JRPP Reference: 2013SYE105

Address of Site: 2-22 Birdwood Ave & 1-15 Finlayson Street, Lane Cove

Application Reference: DA 194/2013

Description of Proposal: Stage 1 Concept Plan for the redevelopment of the site for the purpose of 4 residential flat buildings, basement parking and on-site landscaping

EXTENT OF SHADOWS CAST BY
PREVIOUSLY SUBMITTED PROPOSED BUILDING FORMS
(THE DIFFERENCE BETWEEN THE RED AND GREEN IS THE IMPROVEMENT)

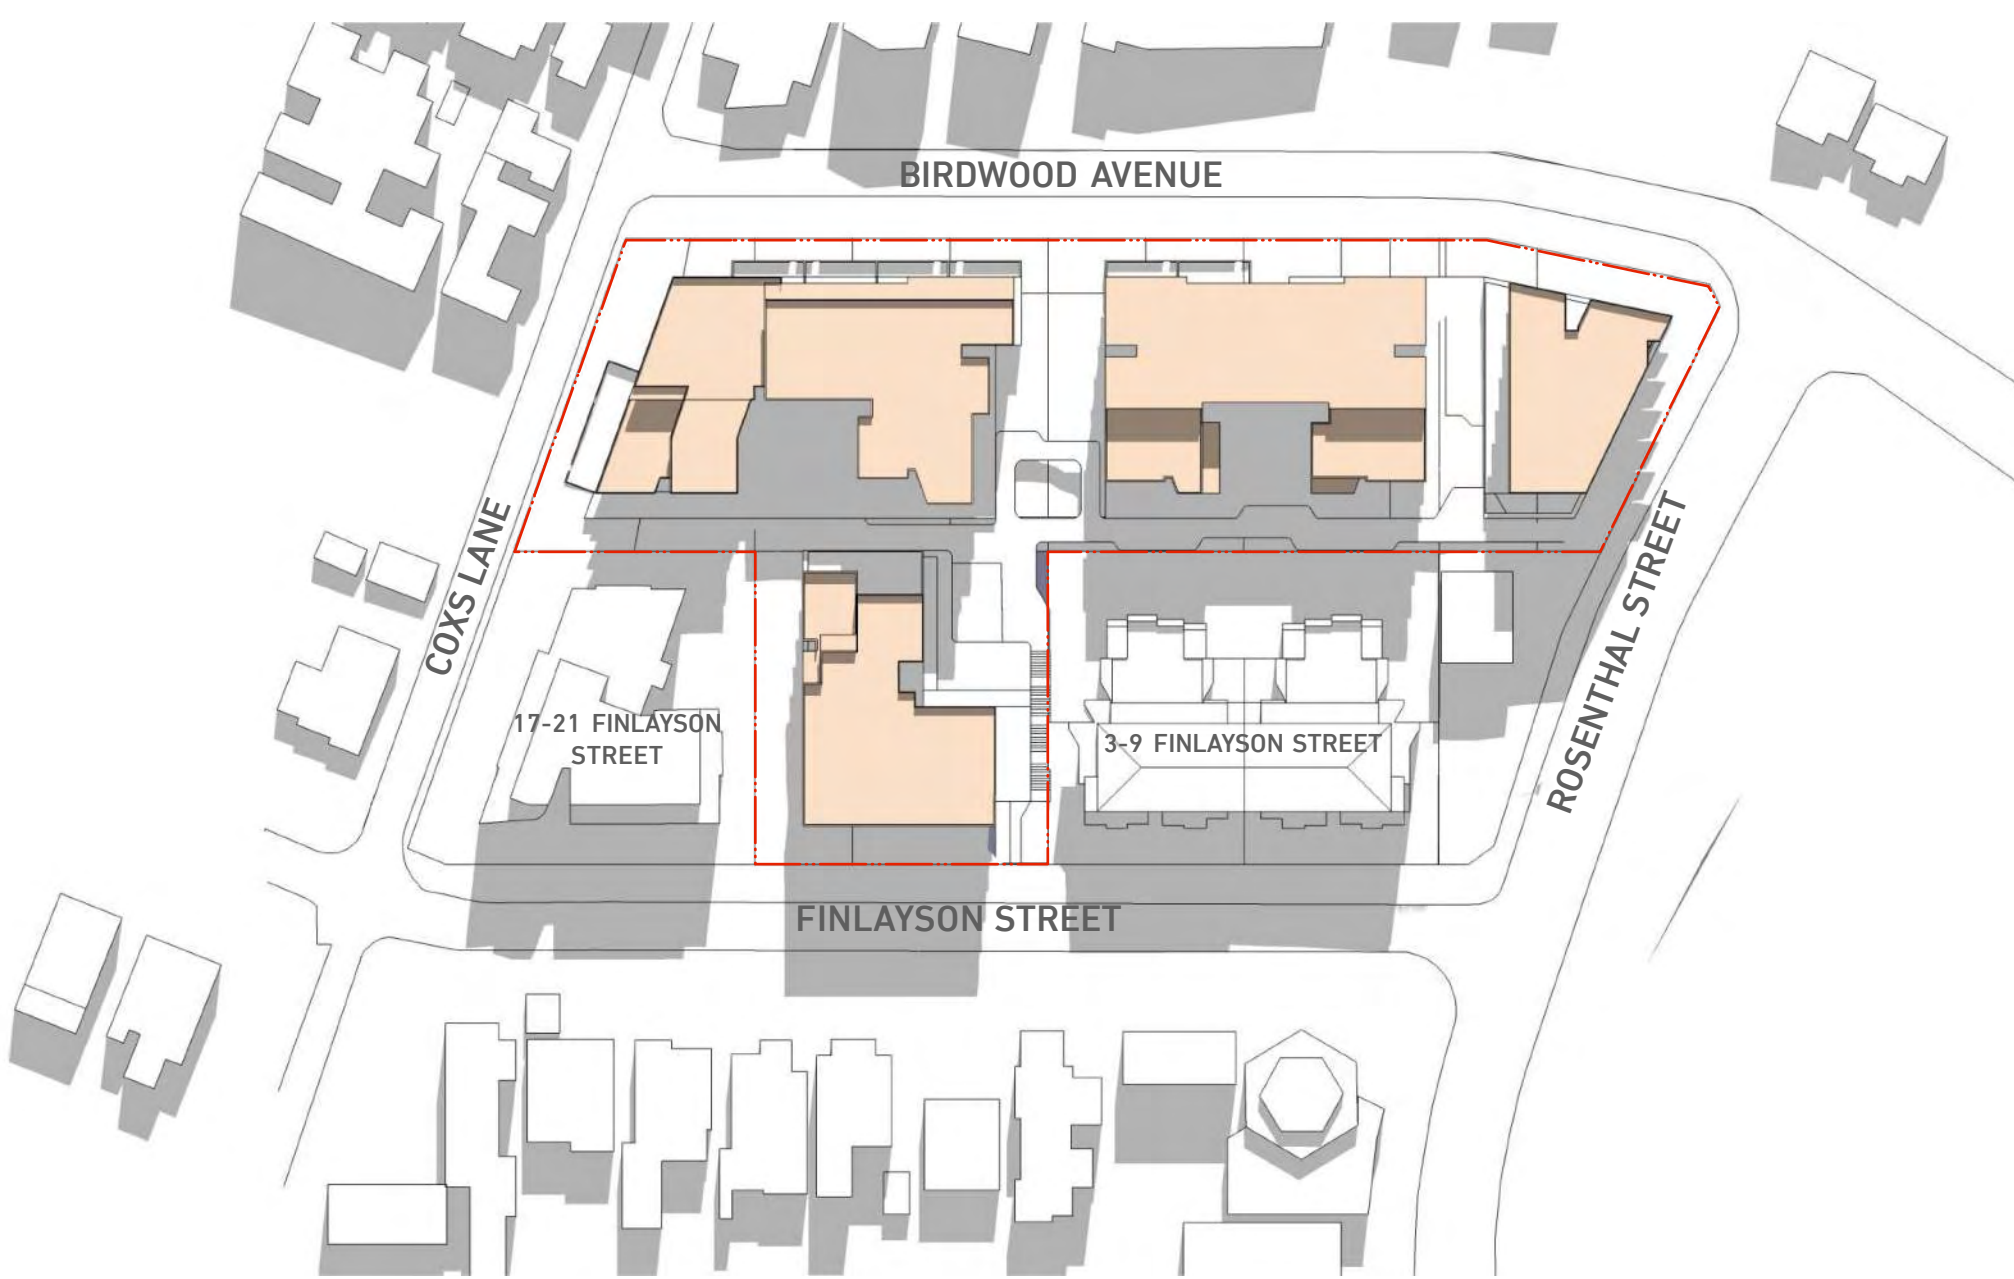
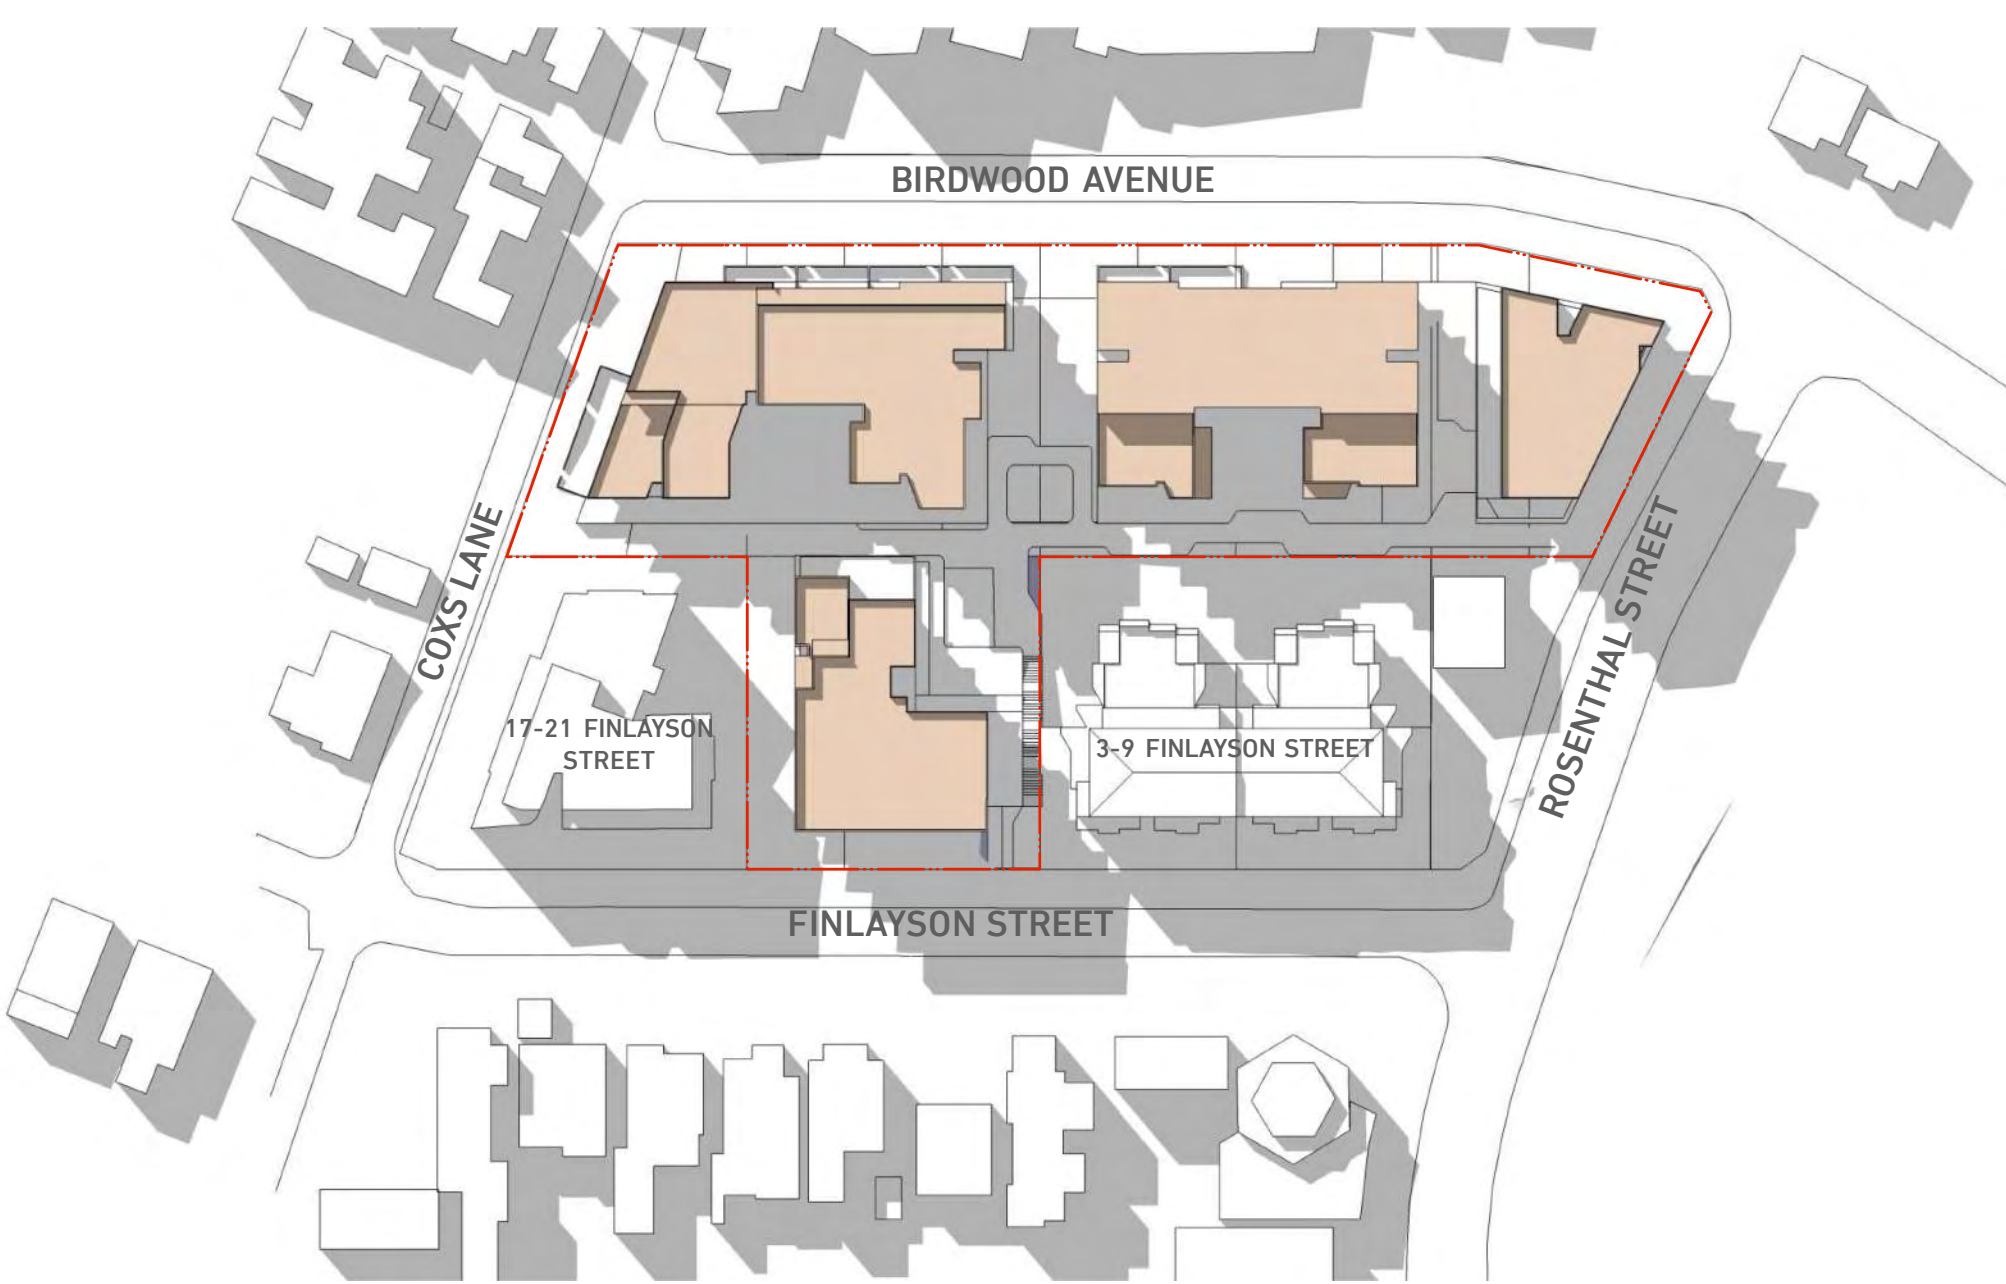
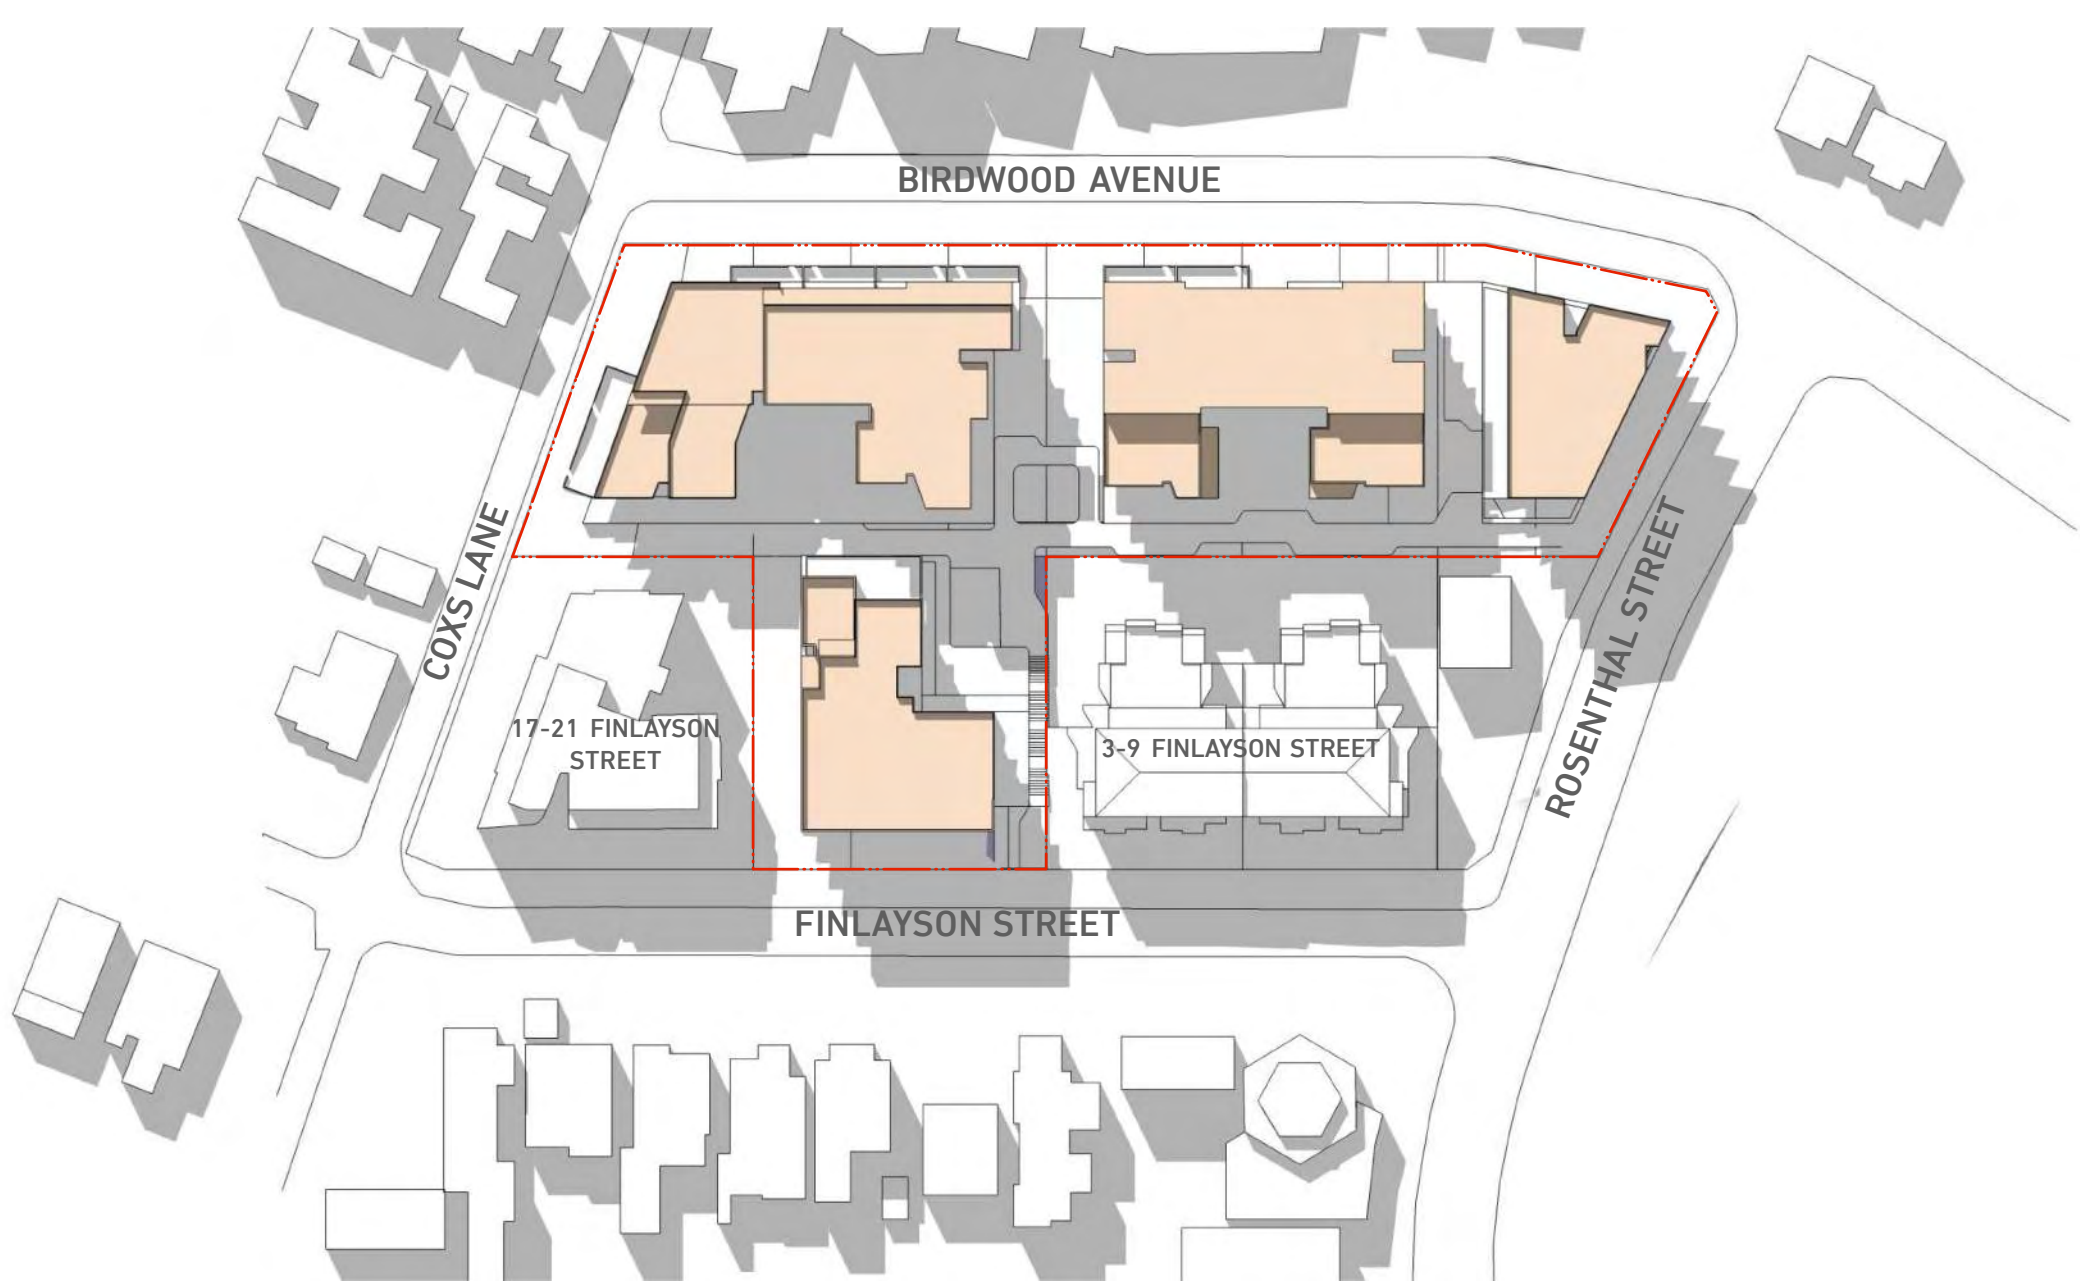
Notwithstanding the above, the proposed amended plans (which will be discussed in the following section of this letter) **improve the level of solar access to the lower level north-facing units of 3-9 Finlayson Street** to a result that is consistent with the RFDC and on balance, better than an outcome from a compliant height scheme.

- 3) Amended mid-winter shadow diagrams for the proposed development to reflect the proposed amendments referred to in 2) above. These diagrams show that proposed Building envelope D does not cast any additional shadow in mid-winter on the eastern-most elevation of the adjacent approved
